BAGHDAD RAILWAY STATION
REHABILITATION
BAGHDAD, IRAQ

SIGIR PA-06-057
JULY 25, 2006

SUBJECT: Report on Project Assessment of the Baghdad Railway Station
Rehabilitation, Baghdad, Iraq (Report Number SIGIR-PA-06-057)

Site Photo 20. One of two electrical sewage pumps in the pump house

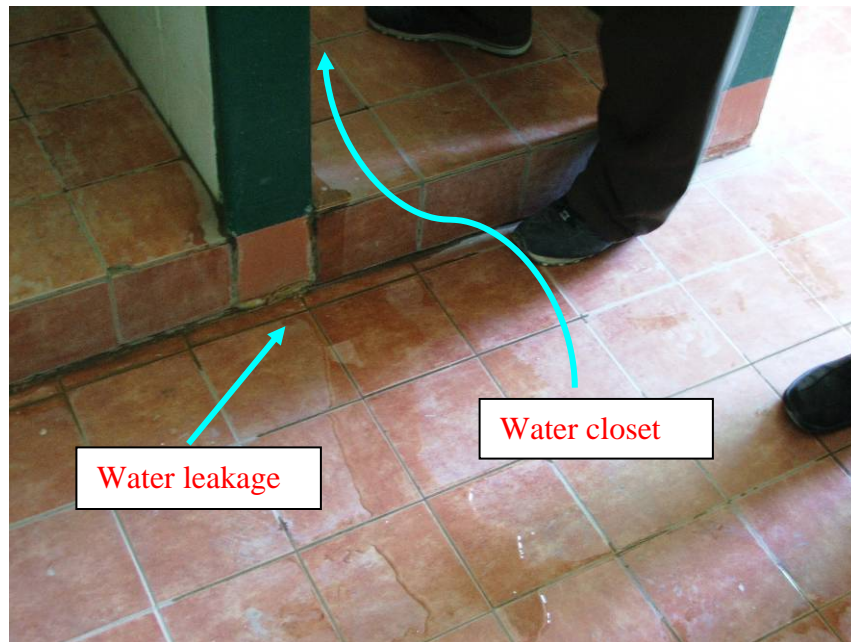
The design required two new sewage station pumps (flow (Q) = 20 m³/hr at 6 m head) in each of the two lift stations. However, the BOQ listed a requirement for sewage pumps with a capacity of 12 m³/hr. We inspected one of the two sewage pump houses (Site Photo 19) and verified two electrical sewage pumps were in place and operating (Site Photo 20). Discussions with the DRE, and a review of catalog cut information indicated the pump capacity at Q= 17 m³/hr at 10 m head.

The IRR has issues with the pumps as noted in a letter to the contractor dated 14 June 2006, indicating the pumps (item 2) need to be heavy duty. The contractor responded that the pumps comply with the submittal requirements that had been approved by the IRR.

At the time of the assessment, the issue had not been resolved, but the DRE, PCO, and representatives of IRMO were meeting to address punch list items, pending modification work, and the issues raised in the contractor's letter.
